INDESIT company

Model type:
WT67EU

Commercial code:
F026970

n1040245: Brembate washing machine basket doors re

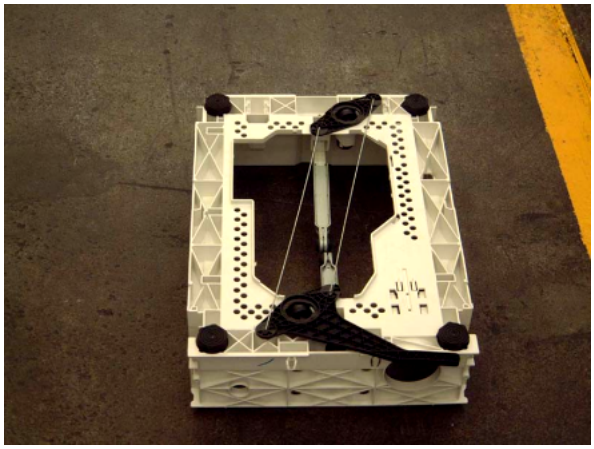
For all washing machine models produced in the Brembate factory and relevant to this note, in replacing the loading mouth code 083895/112743/252375 proceed as follows:
-remove the 18 rivets (9 on the right, 9 on the left) hooking the two doors to the loading mouth on the machine;
-take replacement part 083895/112743/252375 and carry out the same operation described in the previous point;
-hook the two new doors and the new loading mouth on the basket of the machine using the nut and bolts kit code 080691 (formed of 18 screws + 18 washers + 18 nuts);
-use silicone (SAT code 081629) for hooking the loading mouth on the basket.

FIG. 1

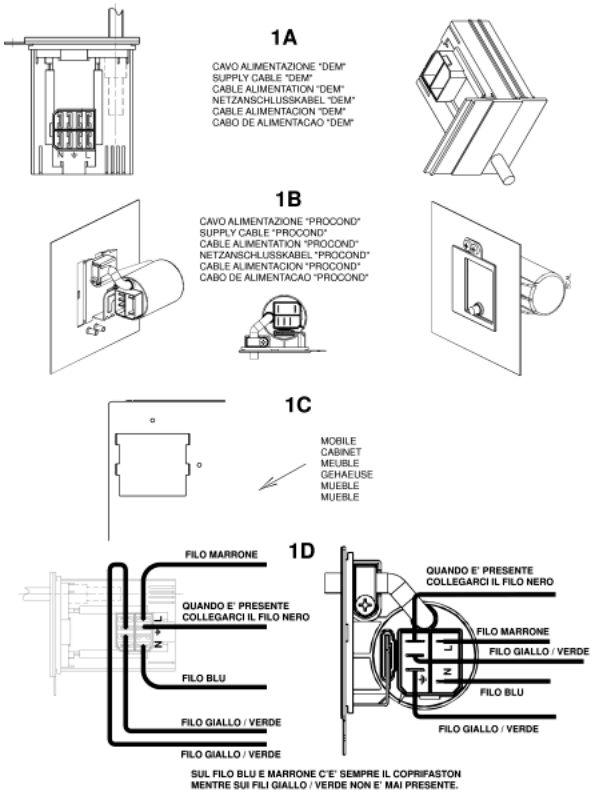
To use premodified wirings on modified products perform the connection to the terminal block of the new cable as shown in fig. 1 - 1D.
The wiring diagrams indicated in the Documentation remain the same.

N1040309FIG1

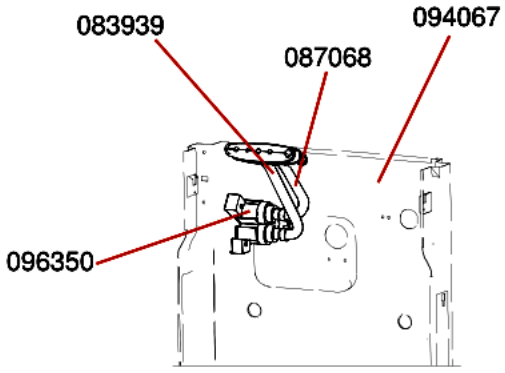
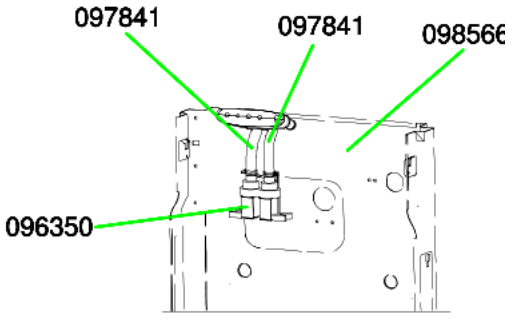
From serial no. 30912.0001, the system used for fixing the loading solenoid valve (spare part code 096350) to the rear panel has been modified on Top Loading washing machines, rotating its position by 90°.
The solenoid valve (spare part code 096350) has been modified with the 45° rotation of a coil; the Replacements Warehouse will continue to manage this part with the same code. When replacing on premodification machines, fit the coils as shown in figure N1040309FIG3-1 and on modified machines, as shown in figure N1040309FIG3-2; to rotate the coil, lift it using a screwdriver and then refit according to the inserts on the plastic.

Replacement codes of the parts affected by this modification (see figure N1040309FIG1):

FIG1 A - PREMODIFICATION STRUCTURE
solenoid valve tube/distributor assembly: premodification 083939;
solenoid valve tube/distributor assembly: premodification 087068;
rear panel: premodification 094067.
FIG1 B - NEW STRUCTURE

solenoid valve tube/distributor assembly: new 097841;
solenoid valve tube/distributor assembly: new 097841;
rear panel: new 098566.

N1040309FIG2

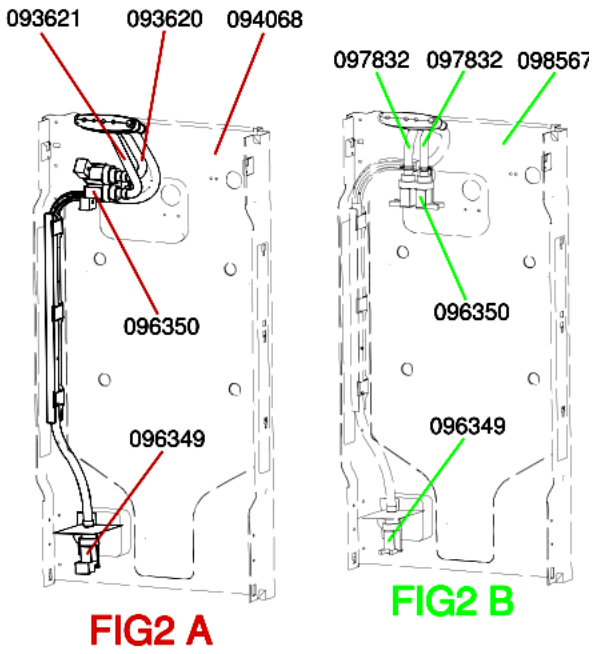
Replacement codes of the parts affected by the modification to WMTL80UK (see figure N1040309FIG2):

FIG2 A - PREMODIFICATION STRUCTURE
solenoid valve tube/distributor assembly: premodification 093620;
solenoid valve tube/distributor assembly: premodification 093621;
rear panel: premodification 094068.
FIG2 B - NEW STRUCTURE
solenoid valve tube/distributor assembly: new 097832;
solenoid valve tube/distributor assembly: new 097832;
rear panel: new 098567.

n1040321: Plastic protecion for solenoid valve.

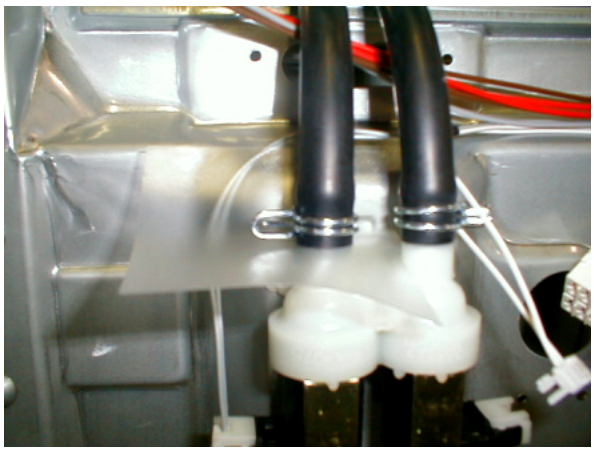
All top-load washing machines produced from September 2003 to February 2004 (from serial no. 30900.0000 to 40300.0000) have been equipped with a plastic protection Service code 109798 (shown in N1040321FIG1), to prevent water from damaging the solenoid valve and electronic card.

N1040324FIG1

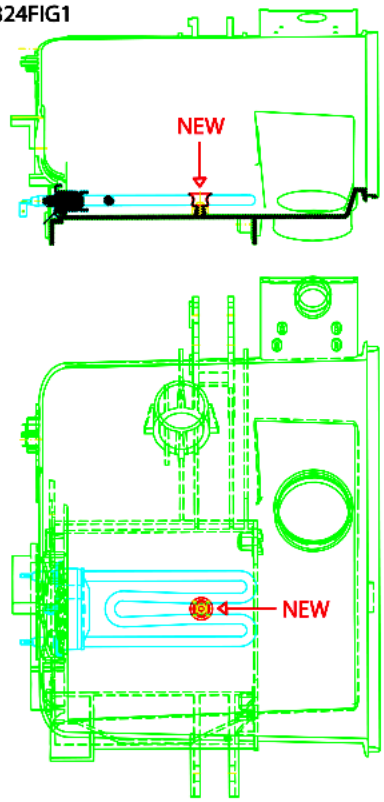
From serial number 40506.0001, the fixing system of the heater to the tank has been modified on all top-load washing machines affected by this note, with the introduction of a metal retainer (image N1040322FIG1 reference NEW) in place of deflector Service code 055322.

The modification has involved both heater and tanks. Given below are the Service codes of the new and old items concerned:

-PLASTIC TANK FOR 600-1000 RPM MACHINES: new 110152, premodification 083805;

-PLASTIC TANK FOR 1200 RPM MACHINES: new 110153, premodification 092023;

-HEATER: new 110148, premodification 083906.

N1040404FIG1

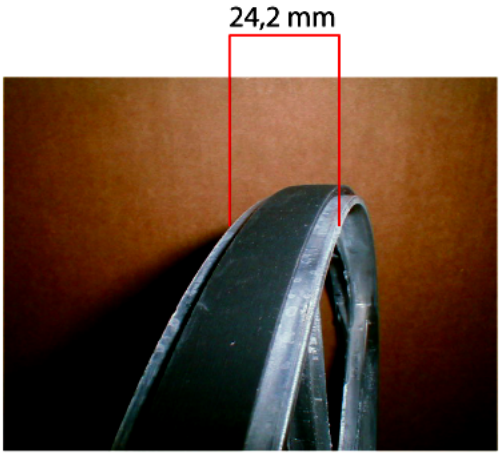
From serial no. 51202.0001 the pulley track has been widened from 21.2mm to 24.2mm (see picture N1040404FIG1).

new pulley
C00142832 - D280 24.2 mm track

Premodification pulley
C00083912 - D280 21.2 mm track
